PCN-20210121 TE0726-03 DDR3 Change and Product Update

Company	Trenz Electronic GmbH
PCN Number	PCN-20210121
Title	TE0726-03 DDR3 Change and Product Update
Subject	BOM change
Issue Date	2021-01-25

This change affects Trenz Electronic boards TE0726 of Revision 03: TE0726-03-*

#1 Change DDR3 RAM (U8) from IM4G16D3FABG-125I to IS43TR16256BL-125KBLI

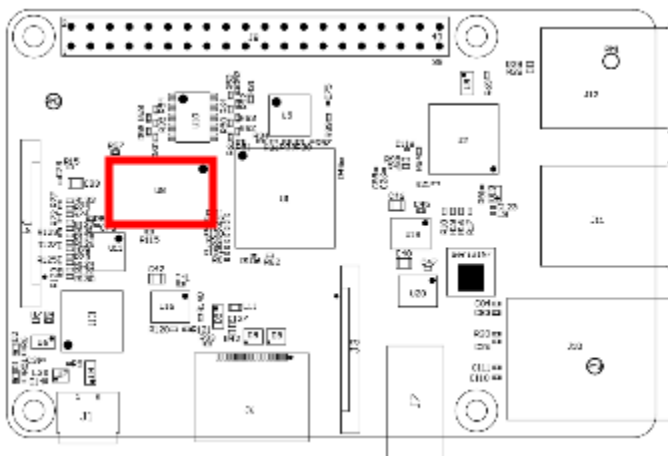
Reason: Component is end of life.

Impact: New DDR timings may be considered in designs.

Locate DDR3 RAM (U8) on top side of PCB:

old	new
IM4G16D3FABG-125I	IS43TR16256BL-125KBLI
<p>IM4G16D3F ABG-125I TW KP9006 1927 1901X772104</p>	<p>ISSI 2001 IS43TR16256BL -125KBLI K096 MLP758000Y1 TWN</p>
